Re: AT&T of Mississippi Utility Permit County Road Name, Mt. Pilgrim Road

The Engineering Department recommends approval of permit application for AT&T of Mississippi for placement of fiber cable by directional bore for the following roads listed below.

PERMIT APPLICATION FOR THE CONSTRUCTION OR ADJUSTMENT OF A UTILITY WITHIN COUNTY ROAD RIGHT-OF-WAY

Bore Detail - FACING EAST SIDE OF MT PILGRIM RD

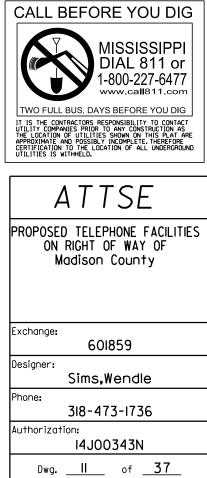
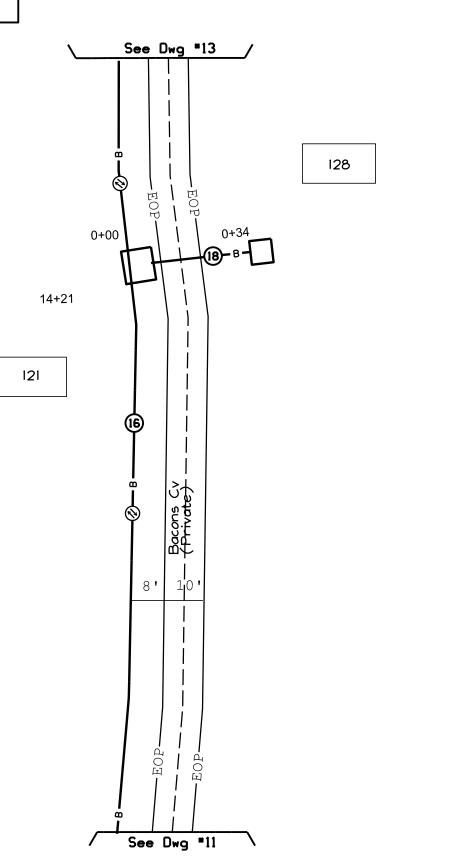
the Right-of-Way of all Public County Roads. Plans are not consistent throughout. There is a note on each sheet stating to place all fiber at min depth of 48" but the bore details in drawings show a min depth of 30" under the ditches. This is the area where the majority of county maintenance takes place and needs to be 48" below bottom of ditch AGREED TO AND APPROVED BY:
